**BEFORE THE QUEENSTOWN LAKES DISTRICT COUNCIL
HEARINGS PANEL**

IN THE MATTER of the Rezoning Hearing -Stream 12
(Upper Clutha Mapping)

**Statement of Evidence of Michael Kelly on behalf of Lake McKay Station
Limited**

**Response to Council S42A Report on Submission 482,
in regard to ONL (Outstanding Natural Landscape) on Lake McKay Station.**

PISA RANGE - LUGGATE

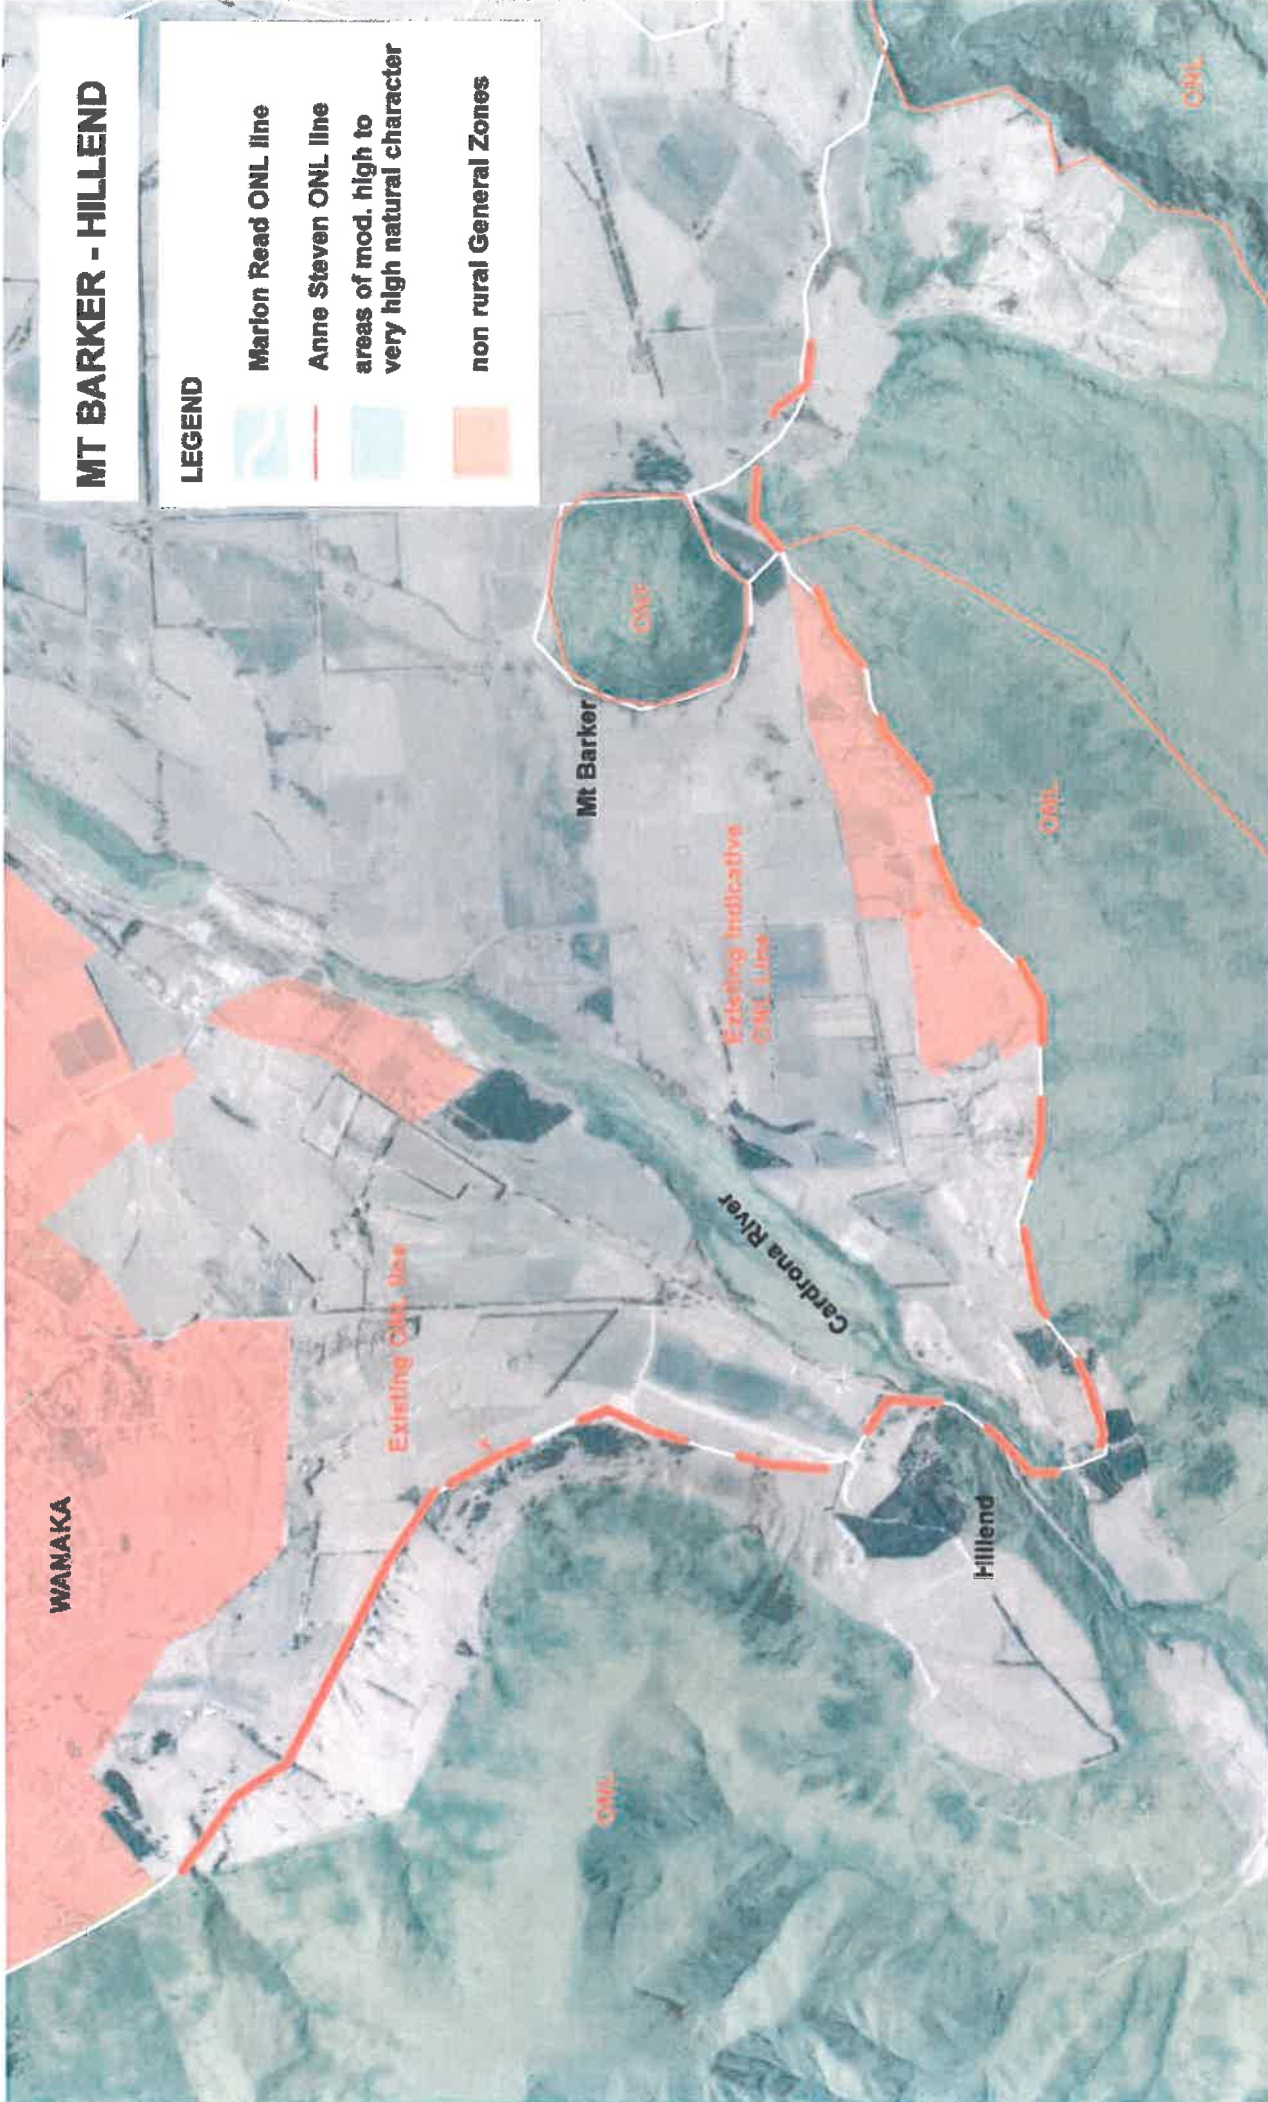
My opinion is that the middle lands of ice-scoured bedrock and moraine veneer is not sufficiently natural. Like the northeast side of Mt Brown, there is a balance of very modified cultivated farmland in paddocks with unnatural patterns of vegetation clearance lying on the smoother moraine veneer lands between very natural incised wooded gorges. This country is not as impressive as other parts and is not a major part of the backdrop generally seen from the basin floor areas to the north. The rock bluffs and Kanuka woodlands around the base of the hills, next to SH6, are very natural with high visual appeal however.

I assess the lower margin of rocky outcrops and kanuka woodland to be an area of ONL, between the district boundary and Luggate township; and, generally, the steeper slopes, bluffs and mountain lands above the farmed plateau to be ONL. This is consistent with the assessment in the Central Otago district. The hill slopes of Criffel Station closer to Mt Barker are considered too modified and scarred by tracking and fence lines to be able to be part of the ONL, being contiguous with modified lands below. Their topography and vegetation is also rather non-descript. The lumpier ice scoured rocky terrain with a greater coverage of Kanuka woodland between the impressive Luggate Creek gorge and Alice Burn is considered natural and striking enough to be ONL.

Knob A3KV

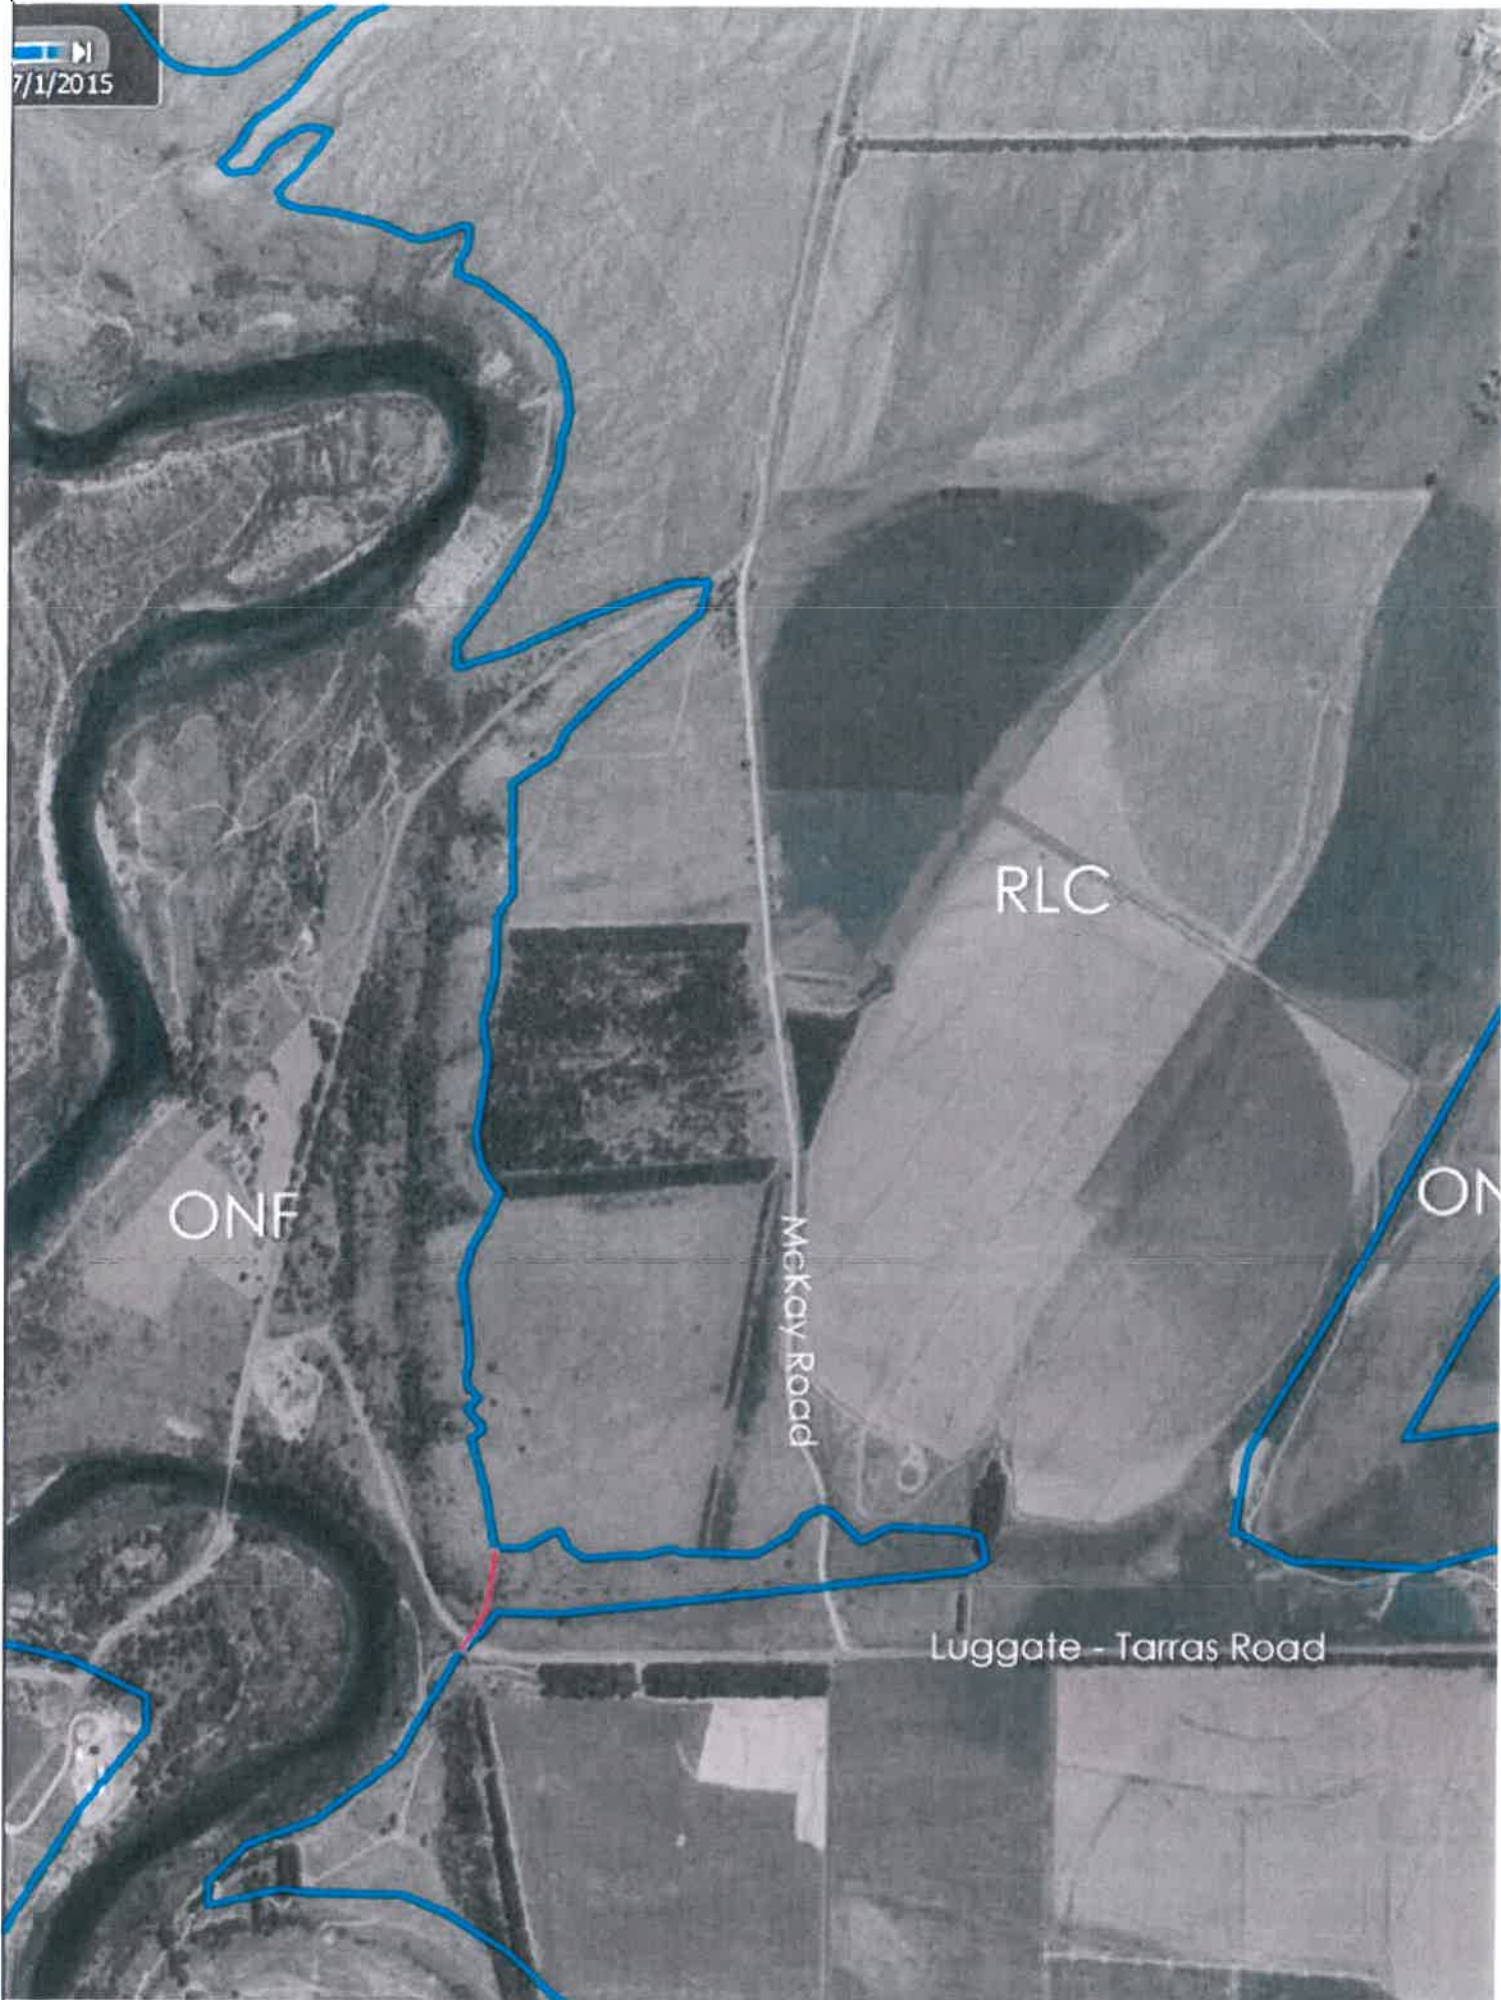
- Dr Read's line bisects a flat paddock area of the terrace, in a way that is unrelated to landform, so as to include a bluff system immediately west of Knob A3KV.

- The bluff system has similar landscape characteristics to much of Knob A3KV, however Dr Read does not include Knob A3KV in the identified ONL.

11. Taking into account all of the above, I consider that the landscape categorisation boundary line should be drawn as shown by the red line on Appendix 1 and 2 of this memo.
12. In summary, the vast, open, rugged, steep, extensively farmed mountain slopes of the Criffel Range have a landscape character that is consistent with an ONL categorisation. The flat, verdant, intensively farmed terraces and valley floor have a landscape character that is consistent with a RLC categorisation.

Figure 4: Notified and recommended ONL boundaries on and near Lake McKay Station, and ONL boundaries sought by the submitter.

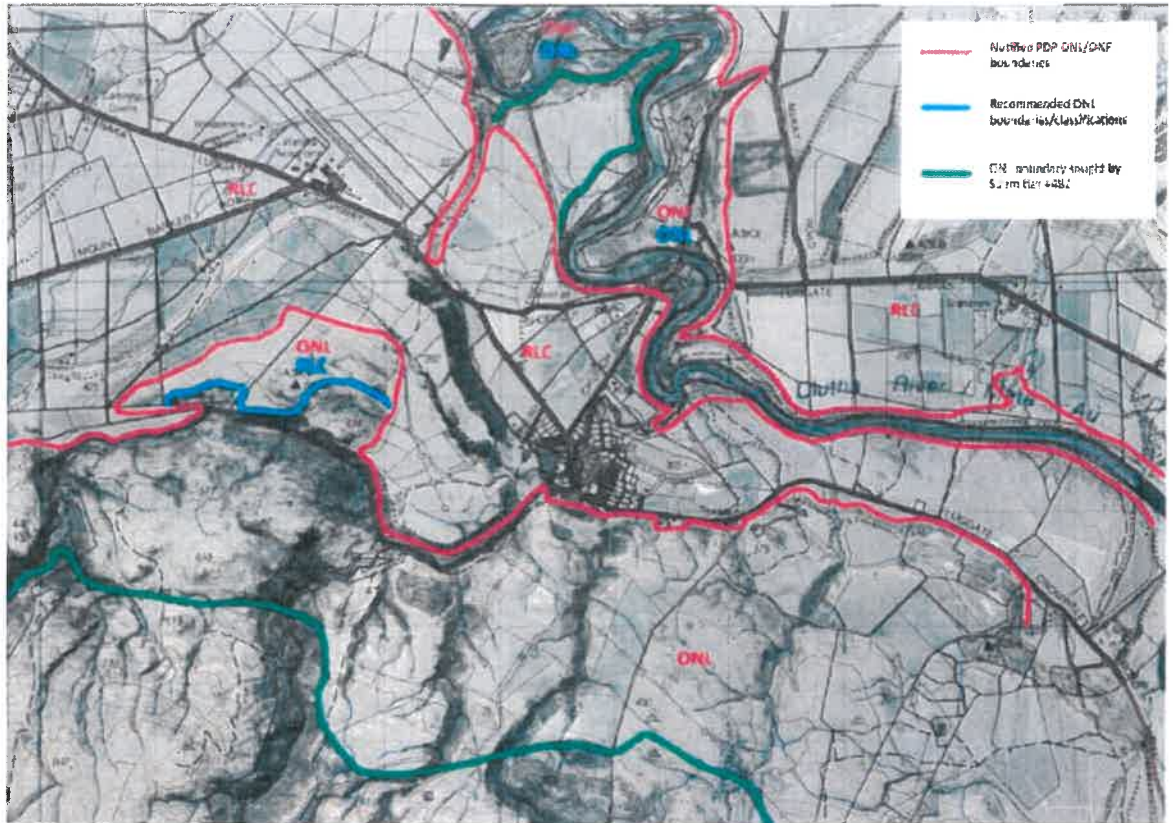
- 5.5. We note that Figure 4 in Ms Mellsops report showed our preferred boundary for the ONL extending into the Rekos Point conservation area which was not the case. Our submission only promoted adopting Ms Read's ONL boundary at this location.
